SERVICE BULLETIN AMATEUR RADIO

SUBJECT	DATE
TS-950SD LOW VS-2 AUDIO	01/12/90

THIS WORK WILL BE DONE ON THE FOIL SIDE OF CONTROL BOARD A/3.

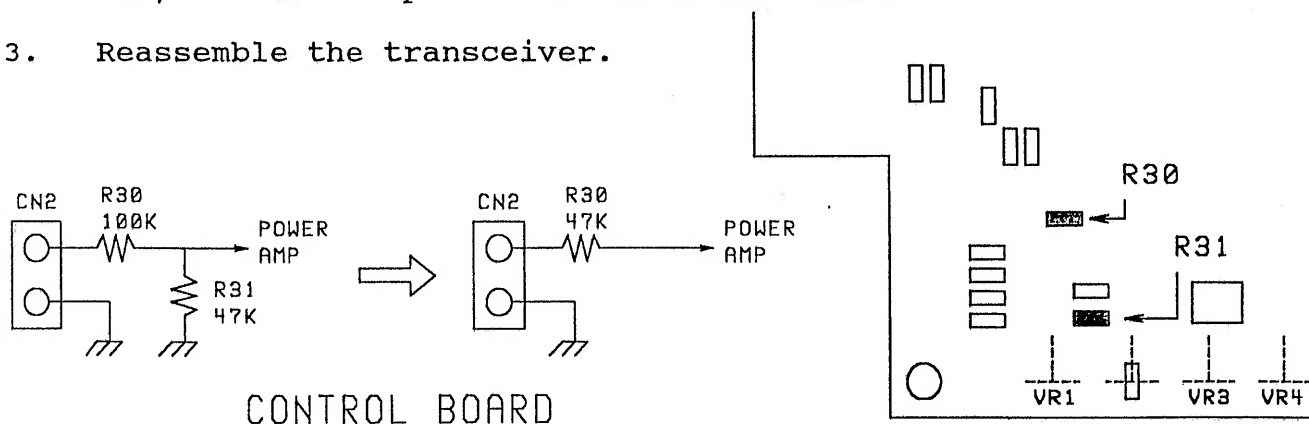
Early TS-950S Digital transceivers will not produce sufficient audio from the optional VS-2 voice synthesizer. The following modification will correct this condition.

1. Desolder and discard chip resistors R30 and R31.
2. Install a 47K ohm chip resistor in place of R30. Do not use R31 (47K ohm) in the R30 position. Use a new resistor.
3. Reassemble the transceiver.

REQUIRED PART: 47K OHM CHIP RESISTOR

PART # RK73FB2A473J
